City of Surrey PLANNING & DEVELOPMENT REPORT Application No.: 7918-0067-00

Planning Report Date: October 21, 2024

PROPOSAL:

to subdivide a parcel into three lots

Appendix I. Proposed Subdivision Layout

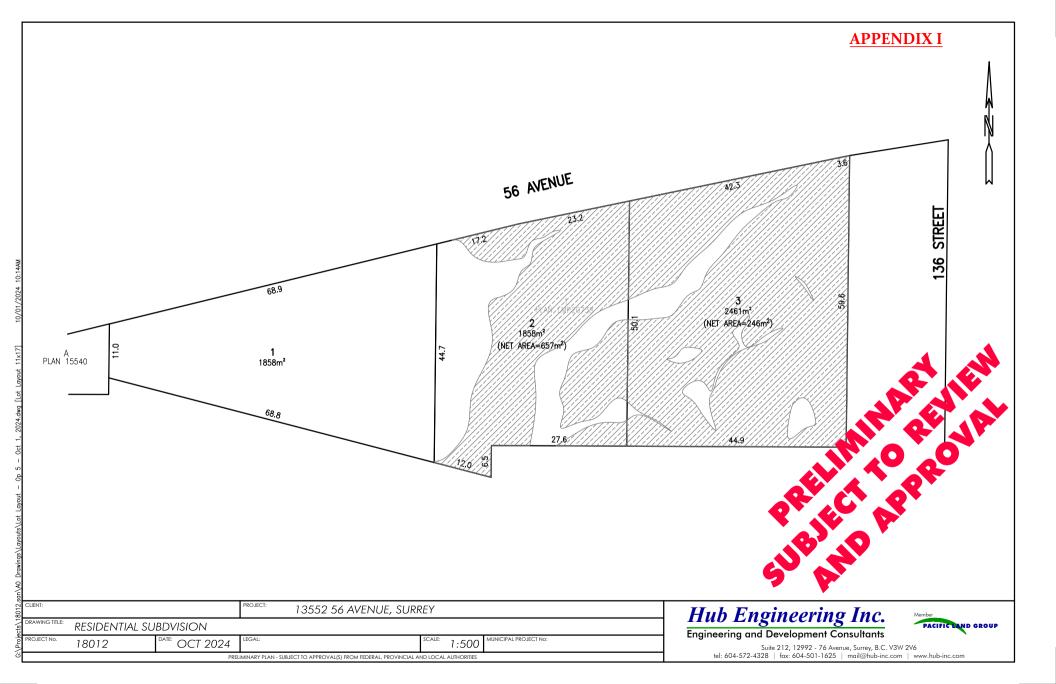
- The proposal does not comply with the Development Permit requirements in the OCP for Hazard Lands (Steep Slopes). Lands within the Hazardous Development Permit Area that are greater than 30% are to be excluded from the lot area calculation when considering subdivision within steep slope areas. When lands with a slope gradient of 30% or greater are excluded from the lot area of the proposed lots, Lot 2 has an area of 657 square metres and Lot 3 has an area of 246 square metres, well below the required 1,858 square metres for subdivision.

- The applicant prepared a building envelope concept demonstrating the locations of the new dwellings on three proposed lots. The proposed building envelopes for Lots 2 and 3 are entirely on the slope and almost entirely within areas where there is a slope gradient of 30% or greater, with the slope gradient on Lot 3 exceeding 40% (Appendix I).

- The applicant prepared a building envelope analysis identifying the location of the new dwellings on three proposed lots. The proposed building envelope for Lots 2 and 3 are almost entirely within areas where there is a slope gradient of 30% or greater, with the slope gradient on Lot 3 exceeding 40%.
